MILITARY SPECIFICATION

MOUNTING BASES, FLEXIBLE PLASTIC FOAM

This amendment forms a part of Military Specification MIL-M-81288(WP) dated 1 January 1966 and has been approved by the Naval Air Systems Command; Department of the Navy

By this amendment basic MIL-M-81288(WP) is changed to MIL-M-81288(AS) and throughout the specification, Bureau of Naval Weapons shall be changed to Naval Air Systems Command

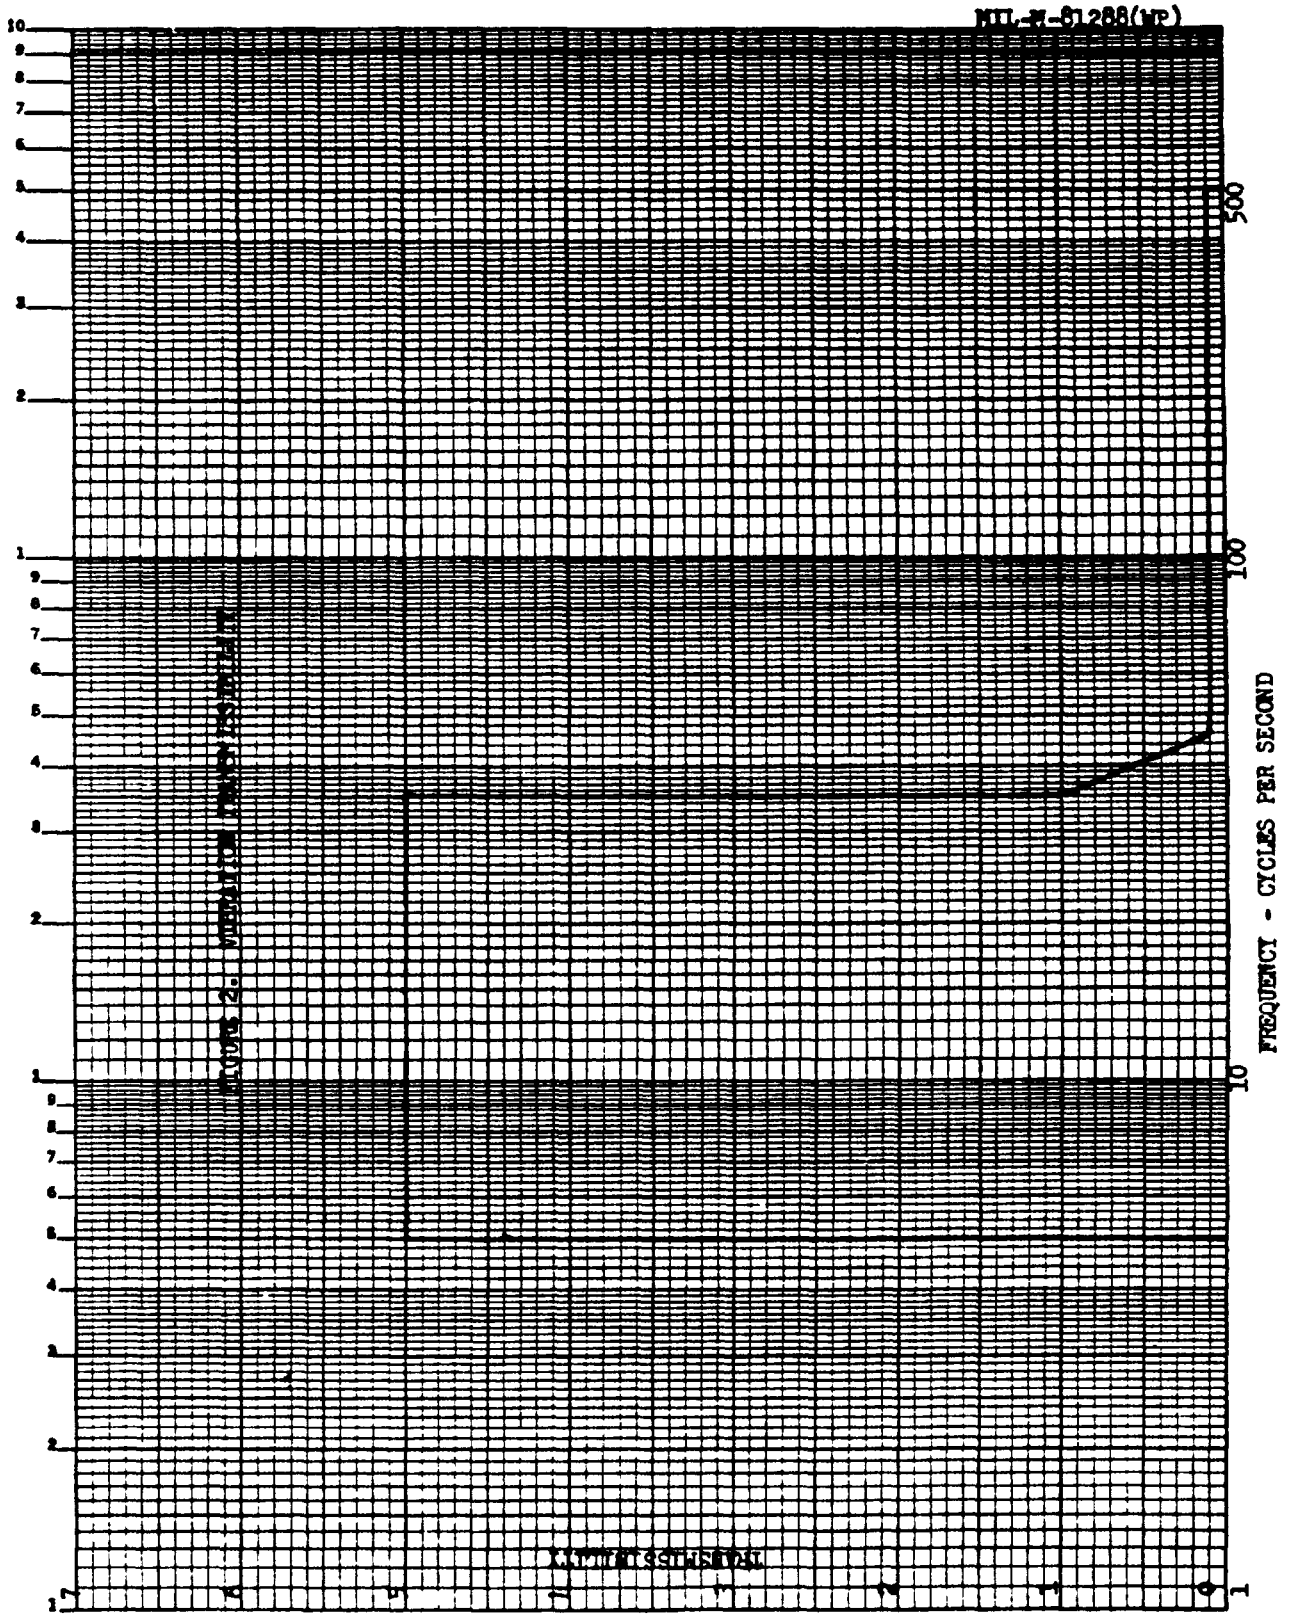
Page 15, Figure 2: Extend right hand vertical portion of curve from 35 cycles to 45 cycles (resulting in one straight line).
